# LAKE MICHIGAN FEDERATION

STATEMENT OF ARNOLD LEDER, PROGRAM DIRECTOR, TO U.S. ARMY CORPS OF ENGINEERS COMBINED PUBLIC HEARING ON ARMY PERMITS 4477305 and 4427402 -- PROPOSED DREDGING PROJECTS, SOUTH WORKS AND GARY WORKS.

Gary, Indiana October 23, 1974

**PROPOSED DISPOSAL SITE**

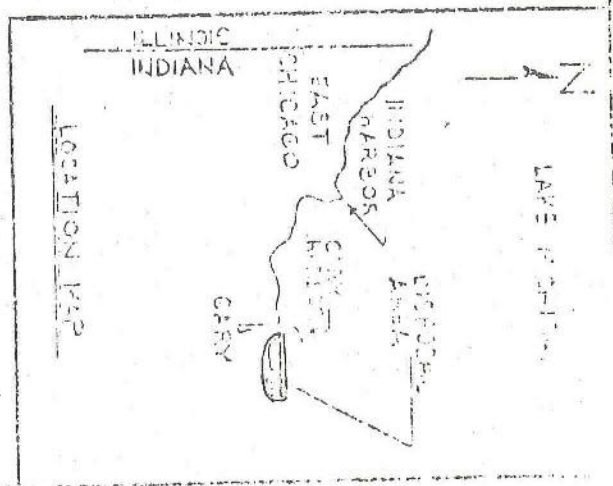
In order to settle suspended solids, the material will be deposited at the west end of the disposal site which is approximately 1.8 miles from the spillway. The spillway consists of four 24 inch corrugated submerged metal pipes at the east end of the disposal area.

In spite of this condition, the Public Notice entitled Application for Permit, dated July 2, 1974, for the South Works project, was accompanied by a chart indicating two barge locations (attachment no. 1). Barge location number 1 being located extremely close to the outfall of the diked disposal area would appear to allow for rapid flow through, thus very little detention time to settle suspended solids. This deficiency should be corrected when developing the permit to reflect the conditions imposed by the State of Indiana.
